## Metallica LE and Premium

**Subject:** Metallica L/E and Premium machines. New firmware for the magnet processor board along with software version V1.22 or higher optimizes the hammer/magnet feature.

LOCATION OF THE  
MAGNET PROCESSOR BOARD

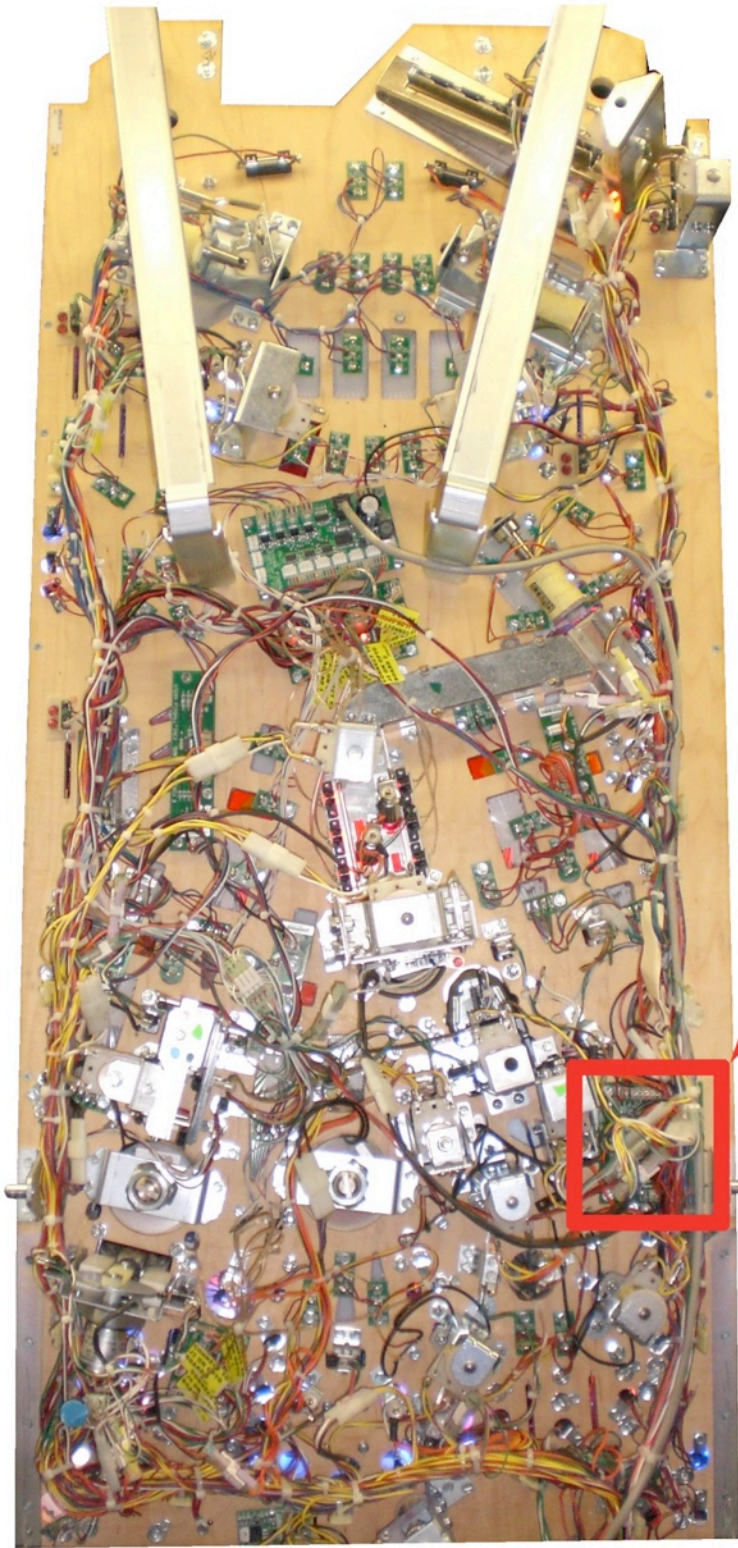
**Symptoms:** False hammer strikes. Or the magnet will grab and hold the ball for a brief moment and release it without the hammer and disappearing ball mechanism activating.

**Solution:** Contact your distributor for a replacement magnet processor board # 520-6801-00. Please note. Games manufactured with serial number # 242584 or higher will have the new magnet processor board.

1. Locate the magnet processor board located under the playfield. (See picture below).
2. Unplug the (3) pin and (12) pin connectors from the magnet processor board.
3. Remove the (4)  $\frac{1}{4}$ " Hex head screws securing the magnet processor board and take the board off of the playfield.
4. Install the new magnet processor board in place of the old board using the (4) screws mentioned in step (3).
5. Reconnect the (3) pin and (12) connectors to the magnet processor board.
